Our Case Number: ABP-313828-22

Re: Demolition of existing building and construction of 5 storey over partial basement mixed use development comprising gastro pub/restaurant with off-licence, 2 retail units, 50 apartments, parking and associated site development works.
Lands at the Silver Granite pub, Palmerstown, Dublin 20

Re: First Party Response to Third Party Appeals – Demolition of existing building and construction of 5 storey over partial basement mixed use development comprising gastro pub/restaurant with off-licence, 2 retail units, 50 apartments, parking and associated site development works on lands at The Silver Granite pub, Palmerstown, Dublin 20

DEVELOPMENT AT THE SILVER GRANITE PUB (REF ABP-313828-22, SDCC REF SD21A/0271)
APPEAL RESPONSE BY NRB – TRAFFIC & ROADS ISSUES

Figure 2 – Proposed Toucan Crossing, including Raised Platform

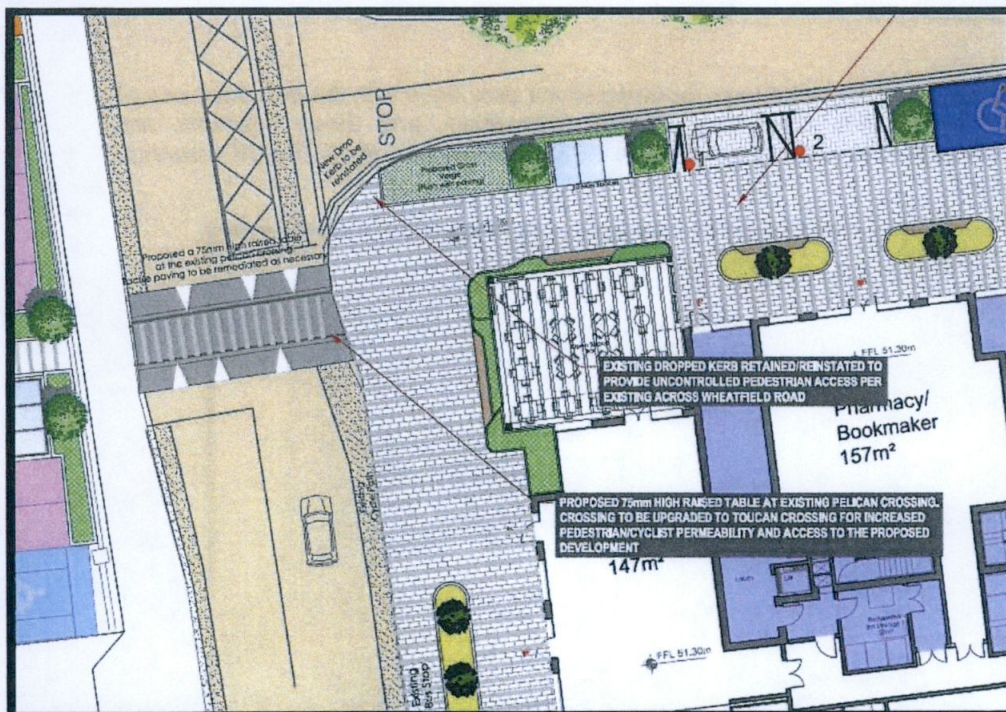
The car parking proposed is consistent with the Design Recommendations for Car parks and best practice. The proposed Toucan Crossing itself is of the correct geometry, it provides adequate sightline & pedestrian inter-visibility and there are no unacceptable conflicts between vehicles and pedestrians/cyclists. It provide for ease of access between the subject site, the associated parking and the Shopping Centre on a desire line, and creates a traffic calming feature consistent with DMURS. And of course it will be subject to the normal independent statutory Road Safety Audit process. For ease of reference an extract from the Plans showing the proposed crossing is included below as **Figure 2**

Figure 3 – Extract from TRACK Drawing Showing Servicing Arrangement

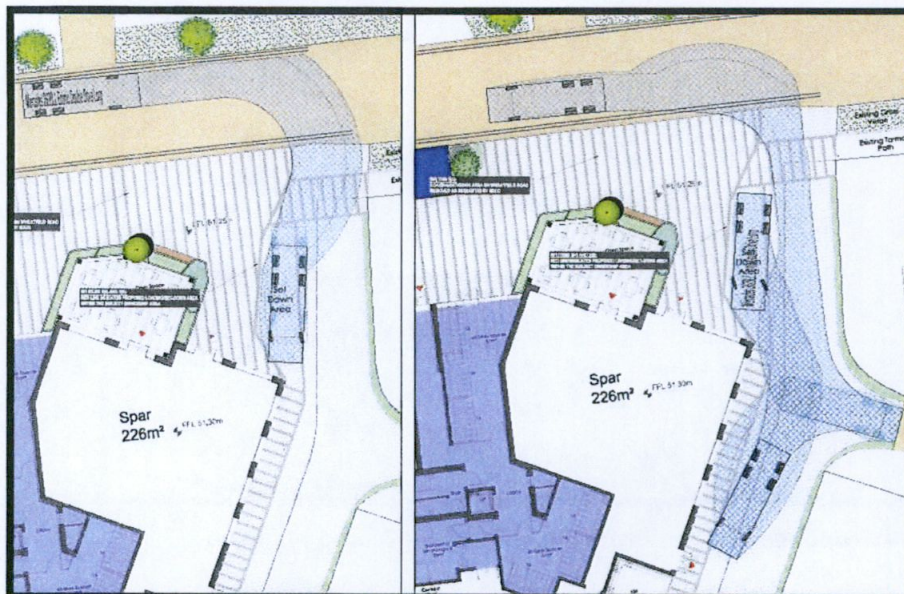
I note that many of the Appellant's and their representatives take issue with the proposed use of the laneway for the purposes of Refuse Collection/Servicing, and these concerns are understandable. For convenience, I include below an extract from the NRB TRACK drawings submitted as **Figure 3**.

I believe that the proposed system, including the nearside indented-bay, will operate in an appropriate, safe and acceptable manner, and this is demonstrated through the TRACK drawings provided. And the safe controlled operation can be further enhanced through the implementation of a Servicing & Operational Waste Management Plan, with the agreement of SDCC.

Figure 3.1: Site Plan indicating the relationship between the proposed development and No.10 Oakcourt Grove

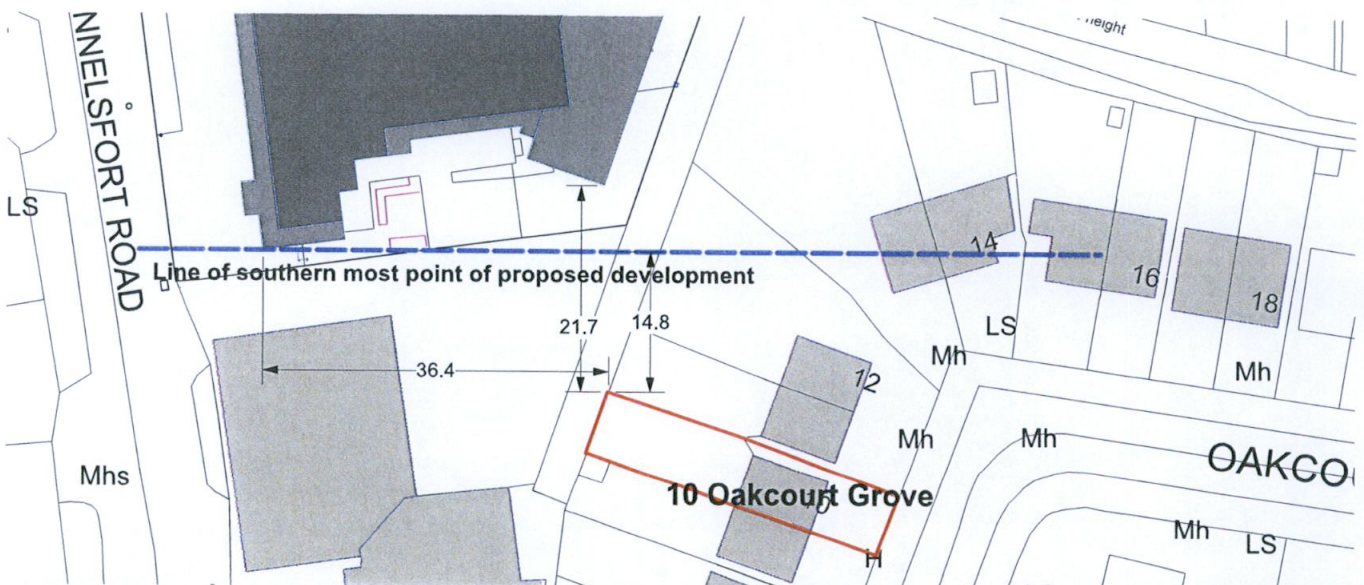
...my house will suffer from the shadow of the development within this location and this is not acceptable. My house will suffer from the shadow of the development and will be seriously overlooked. The apartments proposed on the second, third and fourth floor will be able to look directly in the windows to the rear of my house and directly into my garden space..... No consideration has been taken in the shadow plans from the existing levels of my house (or adjoining properties) relative to the proposed development, the floor levels of the houses and not even shown on the site maps, this can increase and reduce potential impacts and should have been factored into the plans and models.

It can be seen from the shadow diagrams in section 7 in the assessment document that there is no additional shadows cast to the amenity space at No.10 Oakcourt Grove in any of the diagrams.

There will be no additional shading / overshadowing to the dwelling and amenity space at No.10 Oakcourt Grove

Figure 4.1: Site Plan indicating the relationship between the proposed development and No.1 Wheatfield Road, 172 Kennelsfort Road and 215A Palmerstown Avenue.

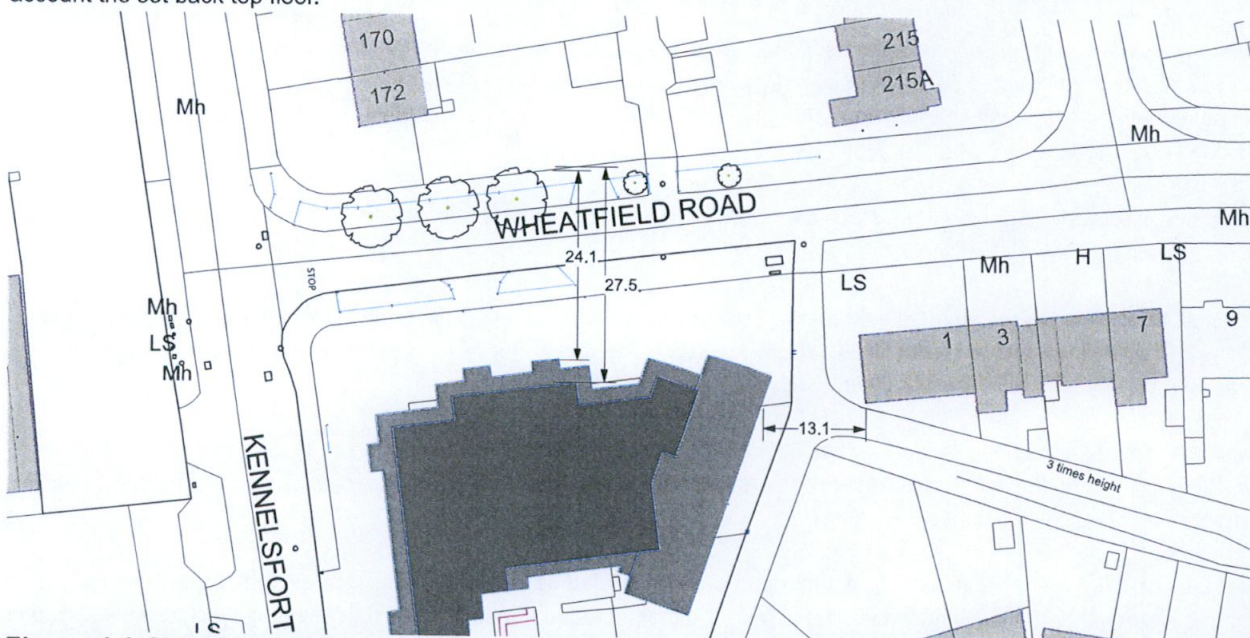
Dr Littlefair who wrote the BRE guidelines has asked in multiple affidavits why it is that Irish assessors can find that the loss of sunlight from a very large new building which is much larger than the one it is replacing can be the same as that from the existing much smaller building. Such statements are repeated in the Applicant planning application. Dr Littlefair points out that it cannot and this has caused ABP to lose such cases. The nearest residential properties cannot experience the same level of sunlight - existing and proposed - all they can do is pass the BRE guidelines. The BRE guidelines are not a standard in themselves but a tool to aid assessment and are not appropriate in all cases. They are not appropriate here. BPS has reviewed the proposed building's shadows via www.suncalc.org and we can confirm that there would in fact be significant overshadowing of the closest rear gardens to the east. They would experience a loss of sunlight throughout the year.

The BPS appeal refers to the use of suncalc.org and additional shading to the rear garden to the East. The objective assessment carried out in Section 6 indicates that the proposed development meets the recommendations of the BRE guidelines and there will minimal and limited shading to No1 Wheatfield Road. The relationship between No1 Wheatfield Road and the proposed development can be seen in Figure 4.2. The proposed development is 13.1m at the closet point to the rear garden of No.1 and the proposed development angles away from the neighbouring property. The section indicates the extent of the shadow in Figure 4.2. The sun angle at 12am on 21st March is 36.62° with a shadow ratio of 1.35. The diagram in the BPS report may not take into account the set back top floor.

Figure 21.0 Shadow diagram from Daylight and Sunlight report (21 June 18:00 GMT +1)

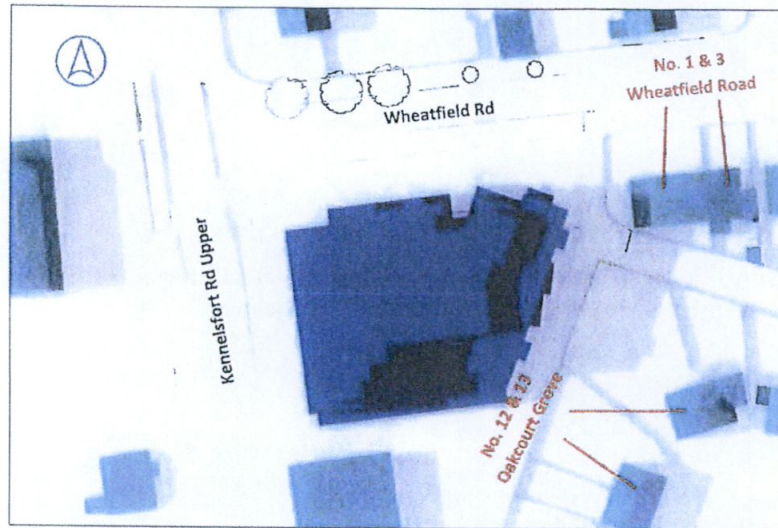
"The proposal is stated to be 'a high-quality development at an underutilised site within an urban setting' and that 'the proposed development will provide appropriate levels of daylight and sunlight and will not give rise to adverse overshadowing'. We refer to the proposed shadow diagram from the Daylight and Sunlight report submitted by applicant, see Figures 17.0-18.0."

The use of shadow diagrams as an assessment method should be taken over the course of the day and not a specific time due to the transient nature of the sun and the shade caused by obstructions.

Figure 10: Existing Radiation map of amenity areas, showing available sunlight on 21st March. The scale represents the percentage of daylight received from 0 - 8 hrs.

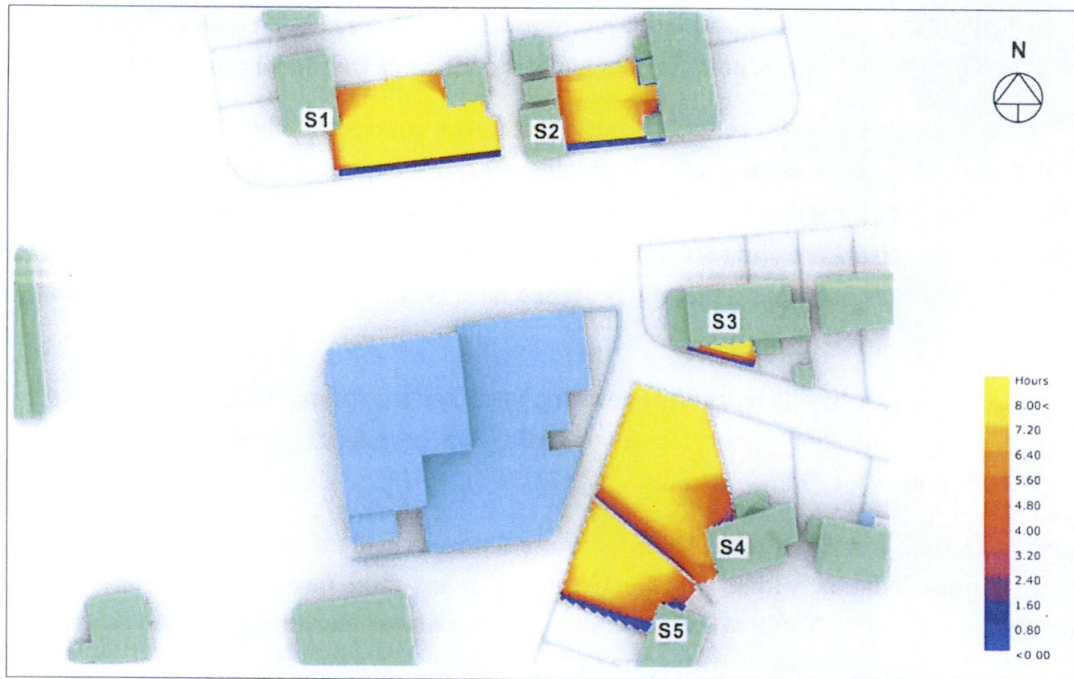
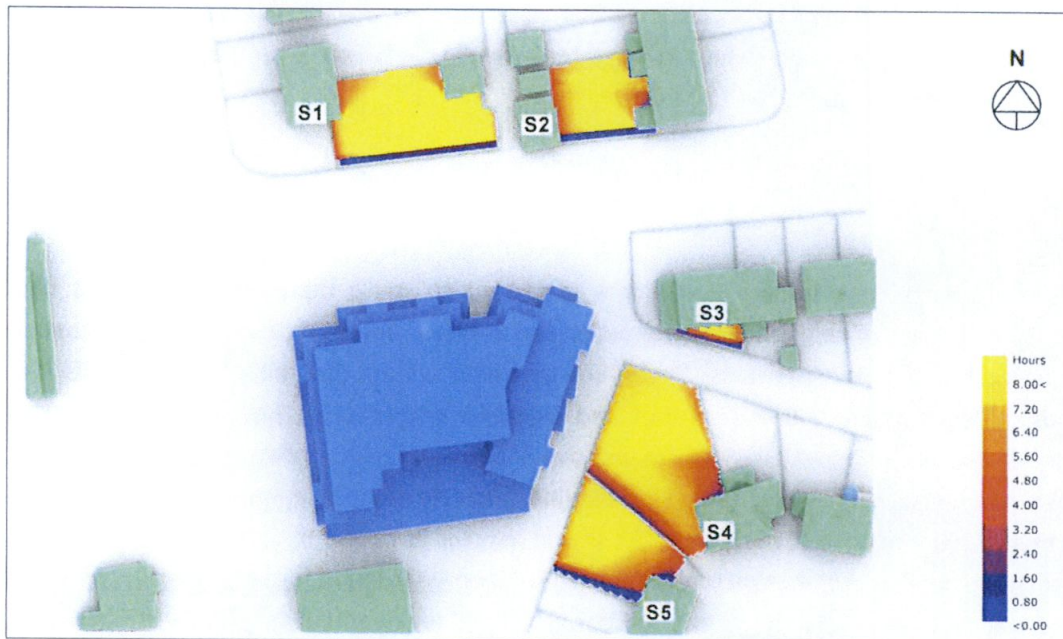
Whilst third-party concerns are noted, it is important to stress that the development has been designed cognisant of neighbouring properties and achieves appropriate separation distances from existing residential developments. There are concerns within the third party appeals that the proposed development will overshadow and overlook neighbouring properties, most notably at Oakcourt Grove. Perceived overlooking and overshadowing chiefly relates to the rear gardens of properties on Oakcourt Grove. The BRE Guidelines indicate that for an amenity area to have good quality sunlight throughout the year, 50% should receive in excess of 2 hours sunlight on the 21st March. It must be recognised that the Daylight & Sunlight Assessment found no impact to the amenity of any adjacent residential properties and the proposed development meets the BRE guidelines for Gardens and Open Spaces.

A separate document has been prepared by Digital Dimensions which contains a comprehensive response to the issues raised within the third party appeals regarding daylight/sunlight and overshadowing. The Bord are invited to refer to this document which provides a full rebuttal on third party concerns relating to the Daylight & Sunlight Assessment.

Figure 12: Separation distances and design intervention prevent and mitigate against undue overlooking

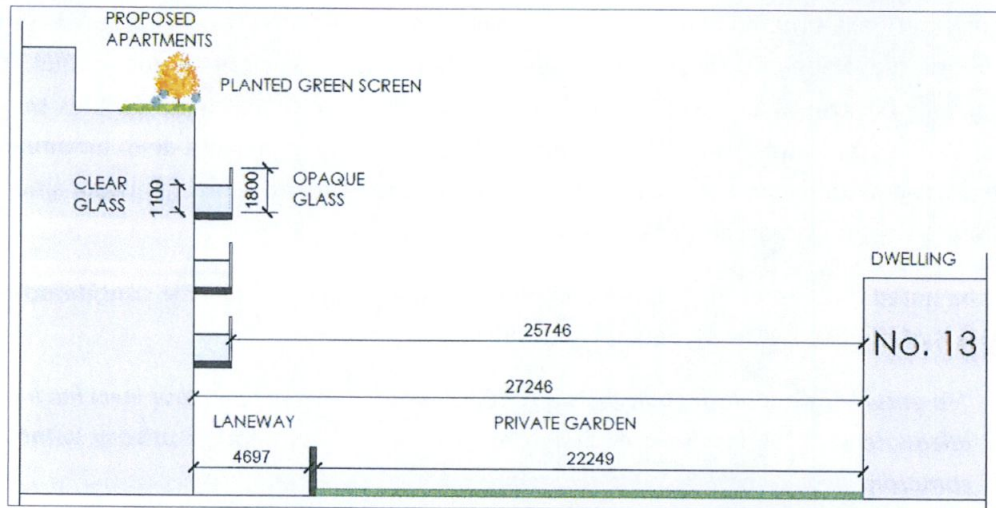
- Every intervention has been made to reduce potential negative impact including the use of 1.8m height opaque balconies at the third-floor level, balconies set at an angle and the use of deep ornamental shrubs. The development achieves the appropriate separation distances from Oakcourt Grove.

Figure 13: Separation distances achieved from dwellings at Oakcourt

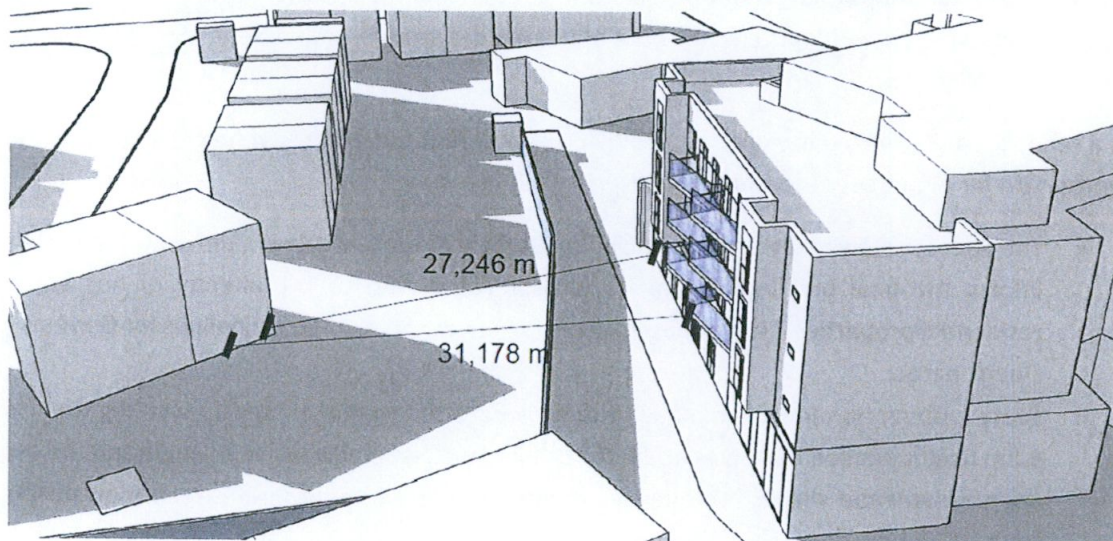
- The proposed development ranges in height from 4 storeys to 5 storeys which means that the proposed height is more than the Development Plan height restrictions. However, it must be noted that whilst the proposed scheme exceeds the stipulated height, it remains consistent with other relevant policies and objectives pertaining to the subject site, and thus the proposed height is justified in this instance. Stipulation of such height restrictions within Palmerstown would be contrary to proper planning and would contradict Section 28 Ministerial Guidelines. Considerations for increasing height within the Draft Plan now utilise the contextual height approach.

Figure 14: Proposed site layout with details on footpaths and carparking

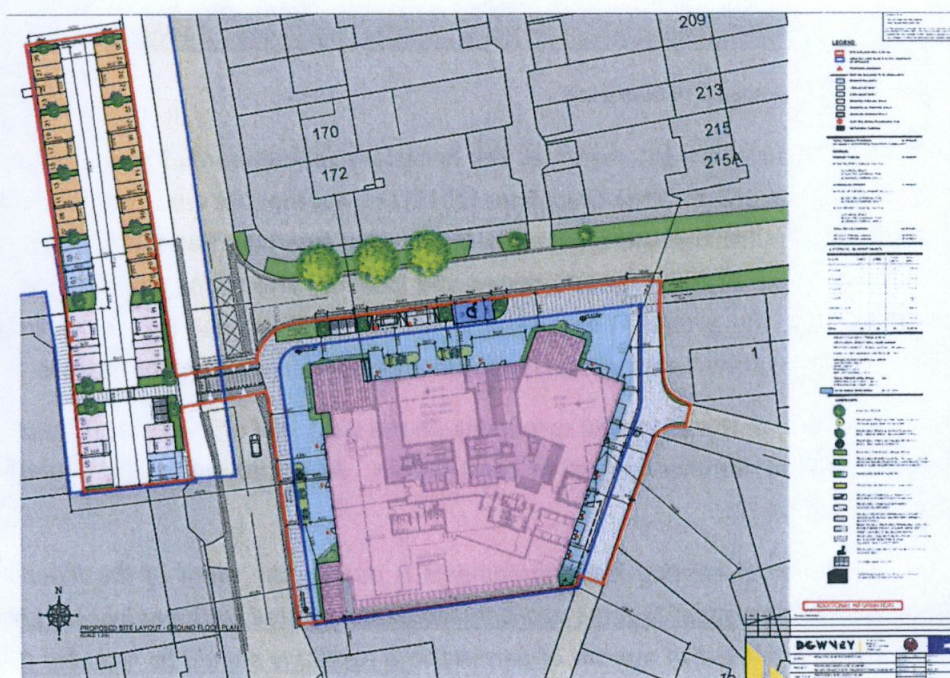
Issues of consent and landownerships have carried through to third party appeals. Joan Sheahan claims that the lands within Folio DN5245 is owned by *Graham Kenny*. DOWNEY can confirm that the lands contained within Folio DN5245 represents a wider folio on public roads/streets, all of which are in the charge of the Local Authority. The Land Registry Register of Ownership of Freehold Land of Folio DN5245 is attached to this Response (Annex 1). Road improvements and upgrades form part of the overall proposed development submitted under Reg. Ref. SD21A/0271 – hence the red line extension at Wheatfield Road, Kennelsfort Road and the laneway at the south-eastern end of the site. It must be noted that the proposed development was subject to pre-planning consultation with South Dublin County Council which included discussions on the road improvements/upgrades proposed. Furthermore, public realm improvements including the upgrade of the existing pedestrian crossing on Kennelsfort Road Upper were welcomed by the Council.
